Model Administrative Change Notice

1. Document Number:	MDL-MGR-GS-000007	2. Revision:	00	3. ACN:	02
4. Title:	Supplemental Earthquake Ground Motion Input for a Geologic Repository at Yucca Mountain, NV				
5. No. of Pages Attached	137	Note: This ACN includes attached electronic media, 1 CD as described in Block 8. The parent document (MDL-MGR-GS-000007 Rev 00) includes 6 DVDs and 1 CD that are electronic media attachments to Appendix D, but the original Model Signature Page/Change History omits any description of these media.

Figure 6.4.4-1. Laboratory Test Results on Tuff Specimens Grouped by Stratigraphic Unit

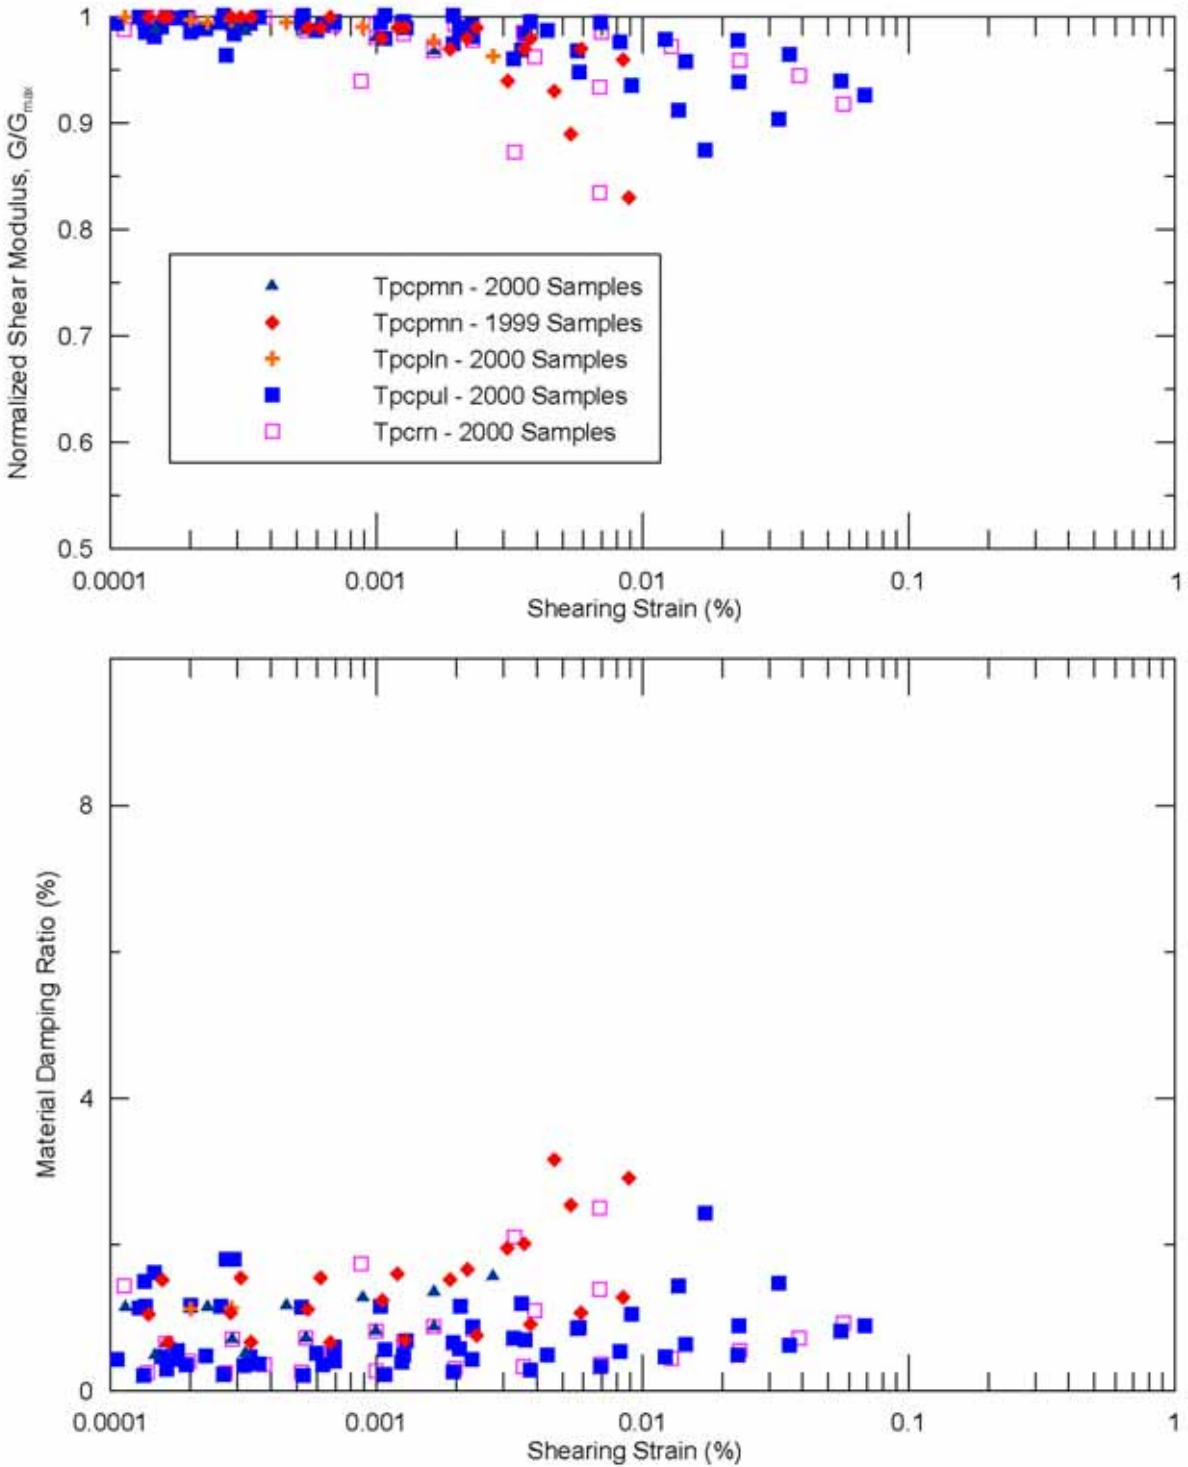
6-236 – 6-238	Made the right-axis scale consistent with the left-axis scale in the upper graphs in each of Figures 6.4.4-1 – 6.4.4-3.

Figure 6.5.2-7. Mean Horizontal and Vertical Seismic Hazard Curves for 30 ft of Alluvium over Tuff, Northeast of the Fault, for PGA at SFA

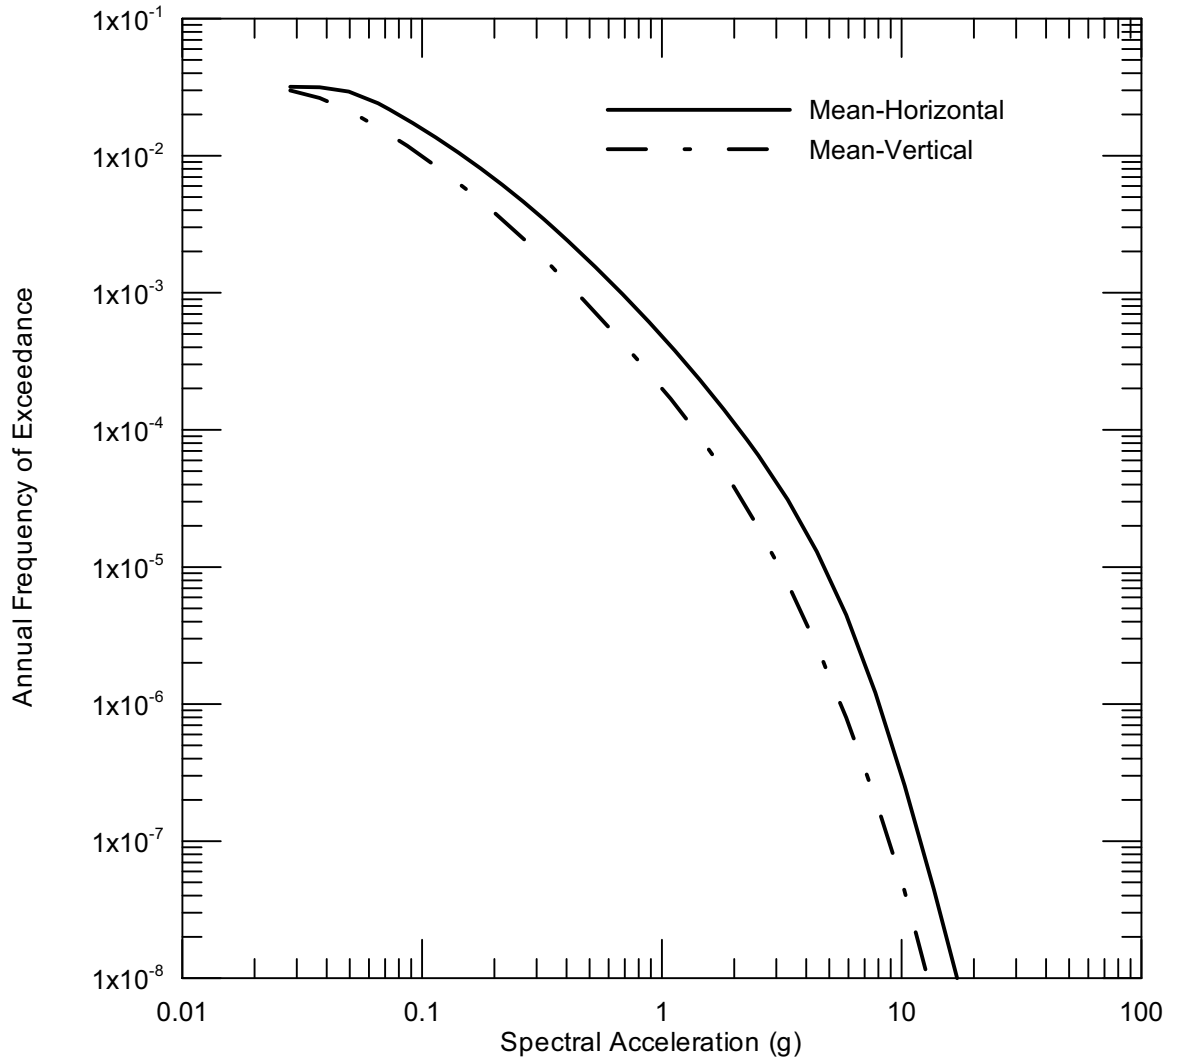
6-285; 6-288; 6-291; 6-297; 6-300; 6-306; 6-598; 6-601	Made the right-axis scale consistent with the left-axis scale and made the top-axis scale consistent with the bottom-axis scale in each of Figures 6.5.2-7, -10, -13, -19, -22, and -28; 6.5.3-3; and 6.5.3-6.				
6-294	Made the right-axis scale consistent with the left-axis scale, made the top-axis scale consistent with the bottom-axis scale, and aligned end-points of the left axis with the left end-points of the top and bottom axes in Figure 6.5.2-16.				
6-309	Made the right-axis scale consistent with the left-axis scale, made the top-axis scale consistent with the bottom-axis scale, and extended the plot of the Mean Horizontal Hazard Curve to include additional high-probability, low-spectral-acceleration data in Figure 6.5.2-31.				
6-310; 6-311	Made the right-axis scale consistent with the left-axis scale and extended the plot of the Mean Horizontal Hazard Curve to include additional high-probability, low-spectral-acceleration data in Figures 6.5.2-32 and 6.5.2-33.
